Response to Submissions

SSD 17_8351

Sydney Metro Martin Place Station Precinct
Concept State Significant Development Application

07 September 2017 | 15879

Figure 2 – Proposed north site envelope (left) and LEP/DCP compliant envelope (right)

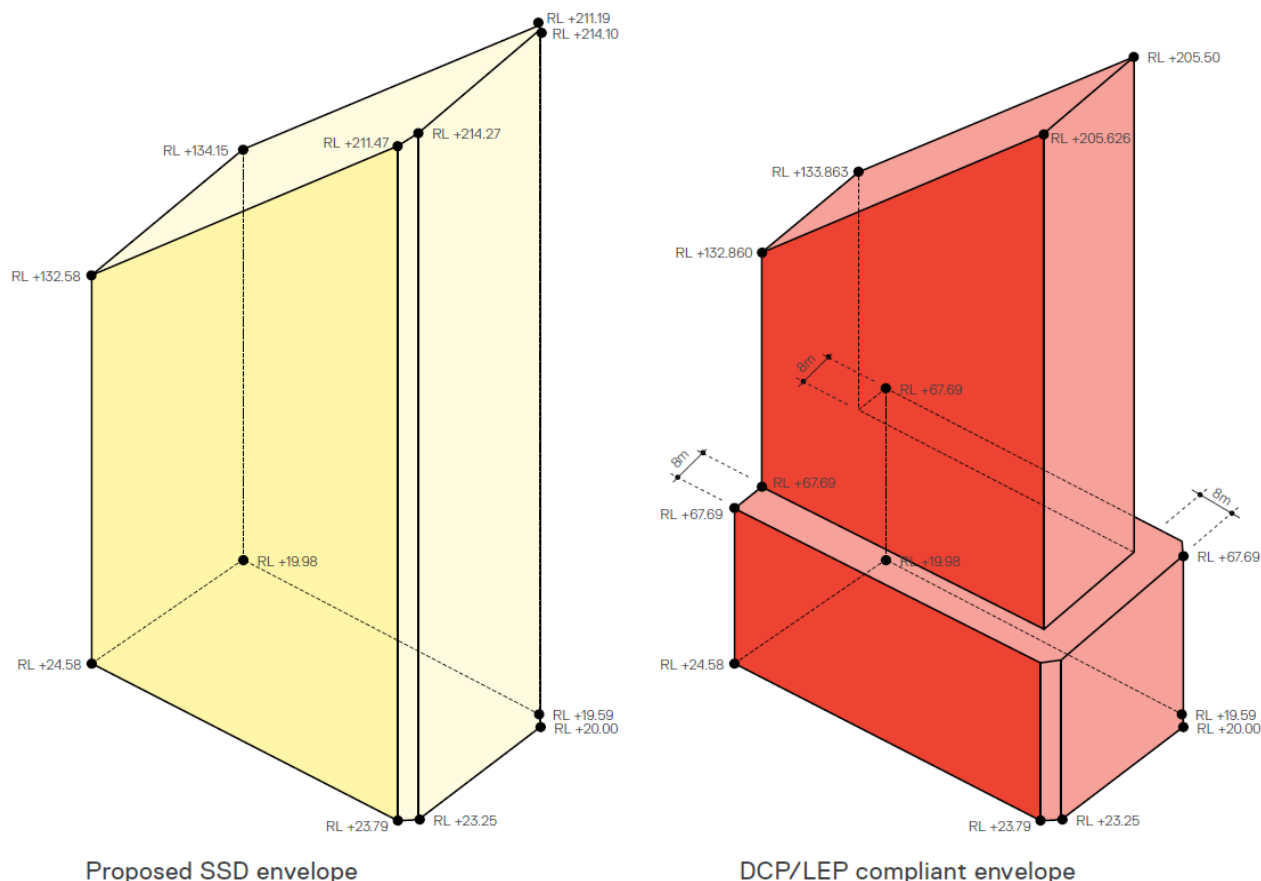
- that a comparative assessment be undertaken against a development which would comply with the floor space ratio control and the setbacks within the Sydney Development Control Plan 2012 (SDCP 2012), in terms of:

In response to the Department's request, a comparative envelope assessment has been prepared for the north tower, which compares:

Figure 2 below represents the proposed envelope compared with the LEP/DCP compliant envelope as per the parameters set out above.

Figure 26- Worst-case scenario overshadowing of Pitt Street Mall on 21 June (additional shadows shown in yellow) at 10am (left image) and 10.10am (right image)

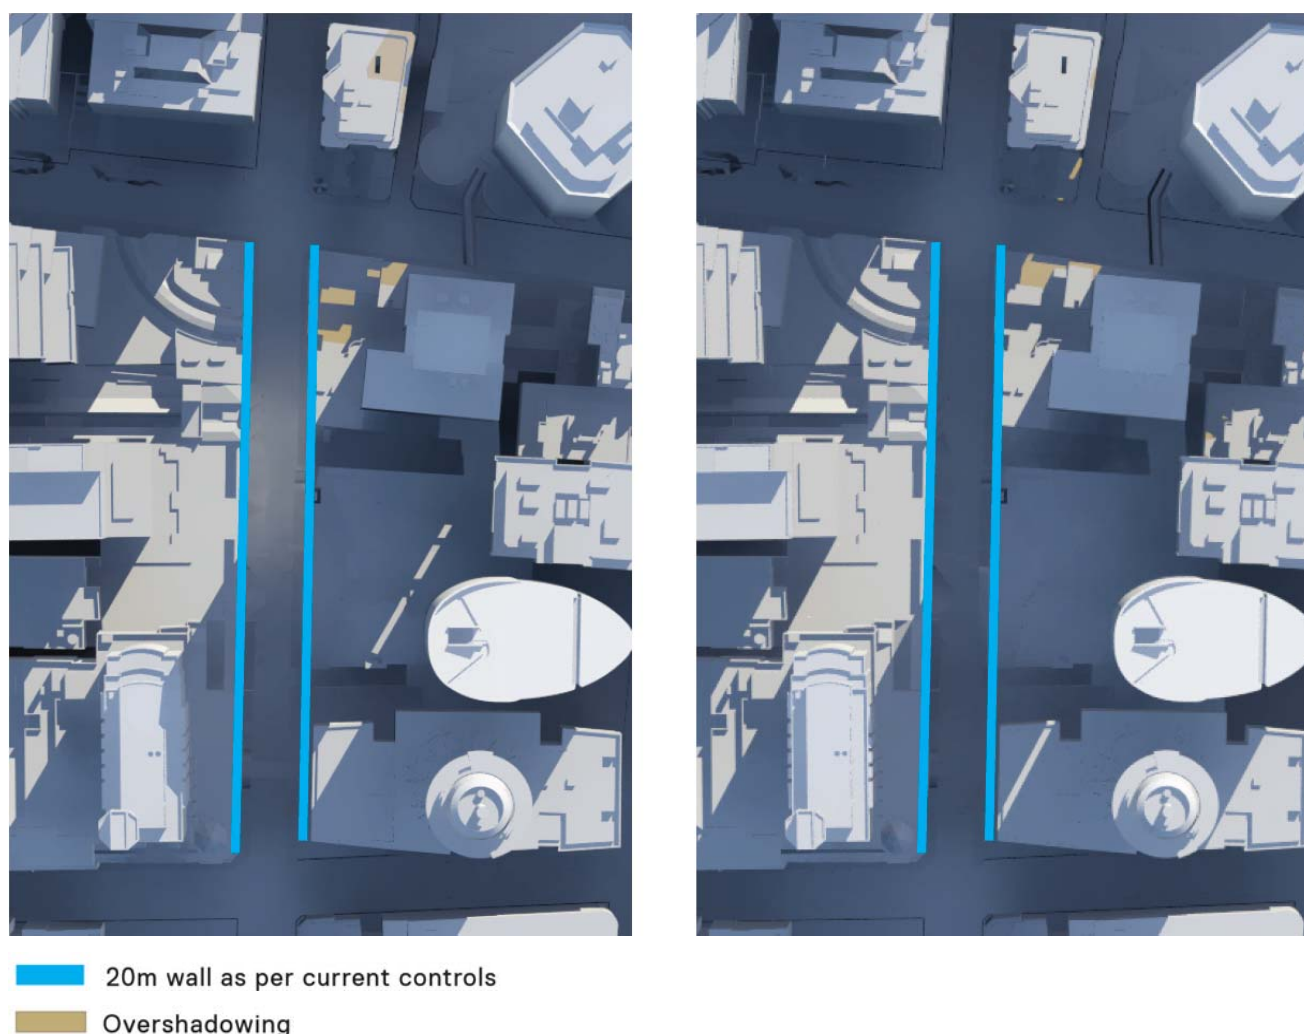
In accordance with this request, JPW have completed detailed shadow modelling between 14 April and 31 August, at the times with the greatest potential to impact Pitt Street Mall. The modelling and associated verification accompanies this report at **Appendix C** and confirms that the proposal will not cast any additional shadows on Pitt Street Mall that would otherwise be cast by a 20m wall on either side of the mall during the control period. In view of this, the proposal is compliant with Clause 6.19 of the Sydney LEP 2012 and is not prohibited under this provision.

Figure 25 below demonstrates that no additional shadows are cast to Pitt Street Mall by the proposed envelopes during the worst-case scenario, being 10am on 21 June (the modelling shown below factors in a 20m street wall on the eastern side of Pitt Street Mall as required by Clause 6.19).
